Proposal for a new UN Regulation on uniform provisions concerning the approval of devices for reversing motion and motor vehicles with regard to the driver's awareness of vulnerable road users behind vehicles

Green: [OICA comments or proposals] Review in progress in OICA.

UN Regulation No. XXX

Figure 3
Class VIII field of vision

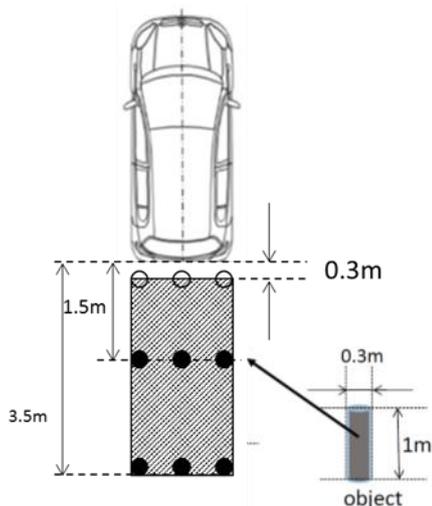
Direct vision exemption to be proposed by OICA.

[OICA PROPOSAL]
